PCN – Process Change Notification

Change:	MA501.D.AC.001
Date:	2016/11/01
Author	Bonnie Chen

Model#	Part Number	Changes
Hercules GENI Screwmount with rubber seal GPS-5M RG-174 SMA(M)/Wi-Fi-5M CFD- 200 RP-SMA(M)-SAW	MA501.D.AC.001	Amend Details of Drawing.

Illustration of Change

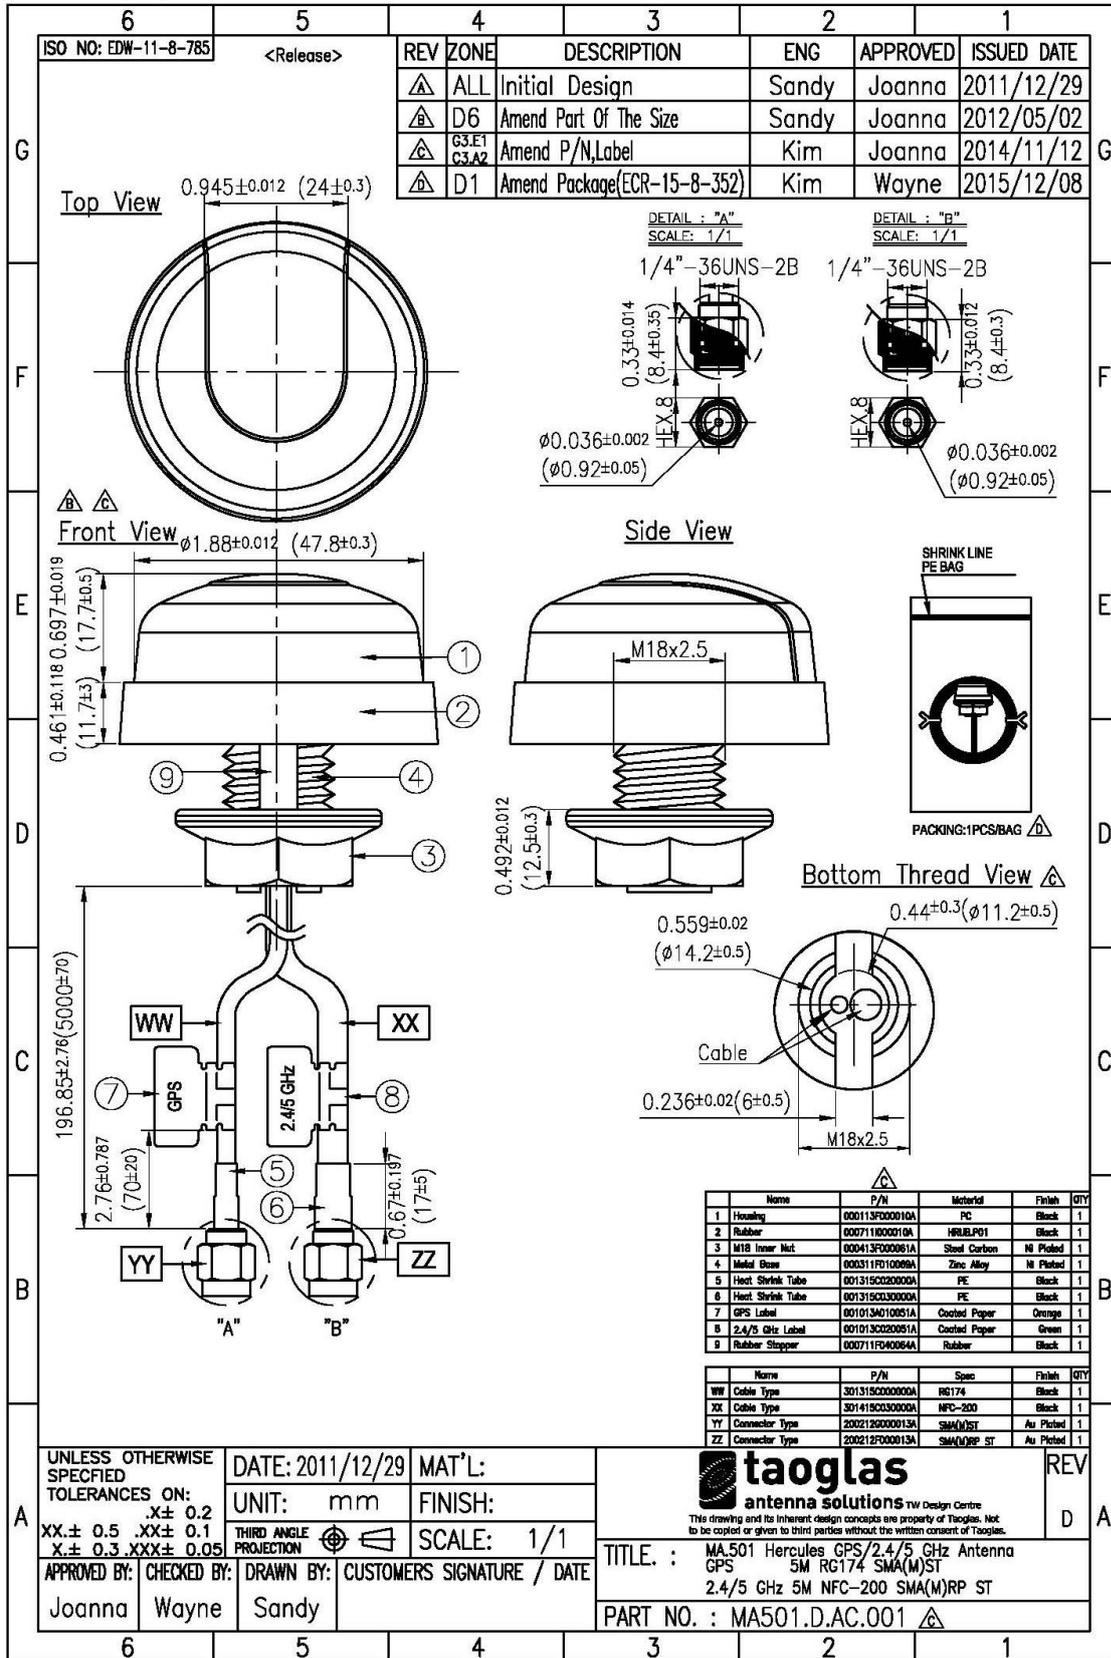
1. Amend Dimension of Nut from 12.5+/-0.3mm to 12+/-0.3mm.
2. Amend BOM.
